SAFETY RECALL

Mack Trucks Inc.
Greensboro, NC USA

Date	Number	Release	Page
06.2026	SC0494	02	1(5)

EPM X3 Connector Exposed AN(4), PR(4)

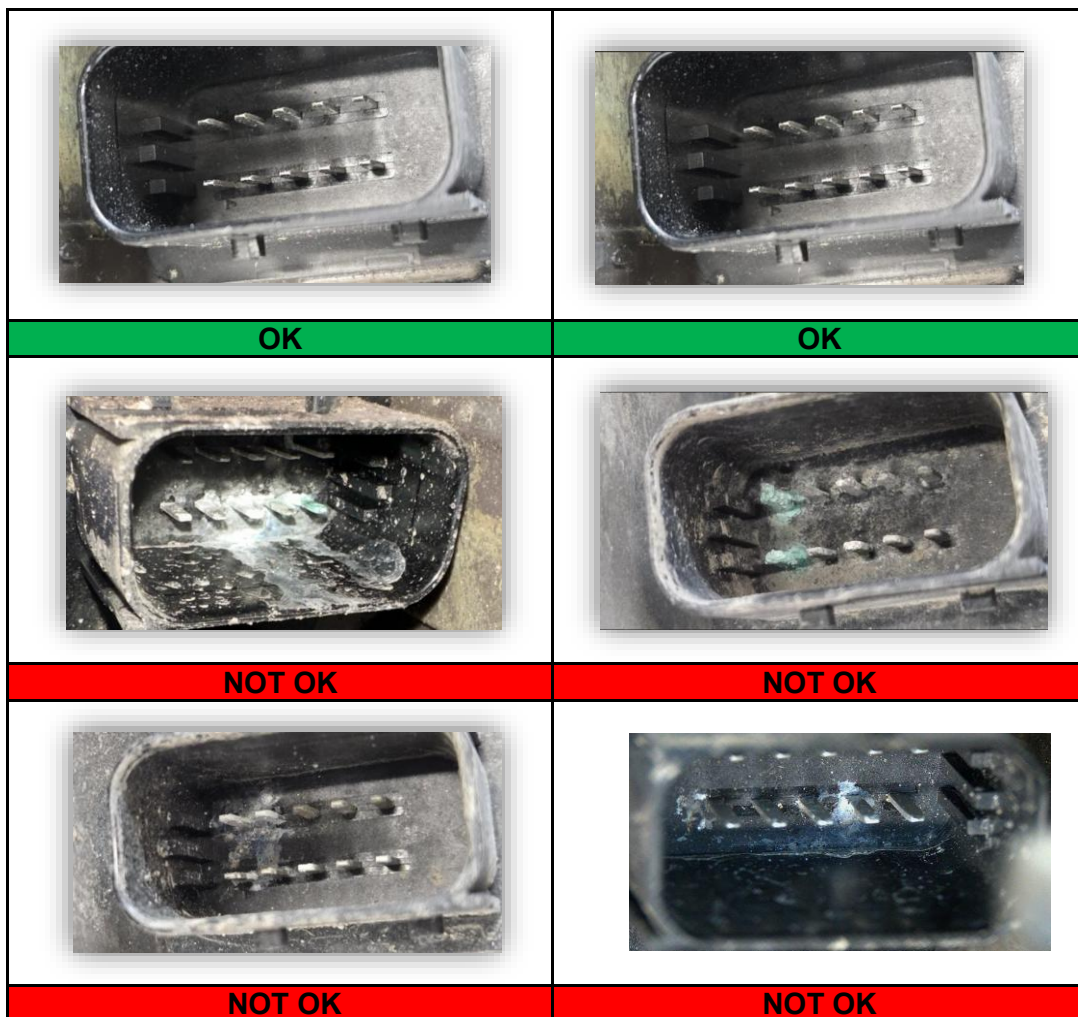
3. Locate the EPM on the rear of the truck. (Driver's side frame rail above the axle).
4. Locate the X3 connector on the EPM and remove the protective cover.

5. Inspect the X3 cavity for a cap or for any corrosion if a cap is not installed.
 - a. If a protective cap is installed on the connector, continue to **Step 9**.
 - b. If corrosion is found in the X3 cavity, continue to **Step 6**.
 - c. If the X3 cap is not installed and the cavity is free of corrosion, continue to **Step 7**.

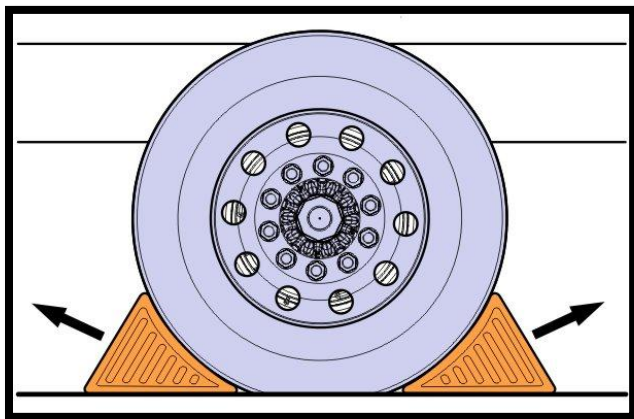
Only replace the EPM if corrosion is found.

6. Replace the EPM with a new one following Impact operation **5600-03-02-02 Modulator, Rear, Replacement**. Before installing the EPM add the protective cap **995115** to the X3 cavity.
7. Ensure cavity is clean and dry.
8. Install the protective cap **995115** on the X3 cavity.
9. Install and latch the protective cover.
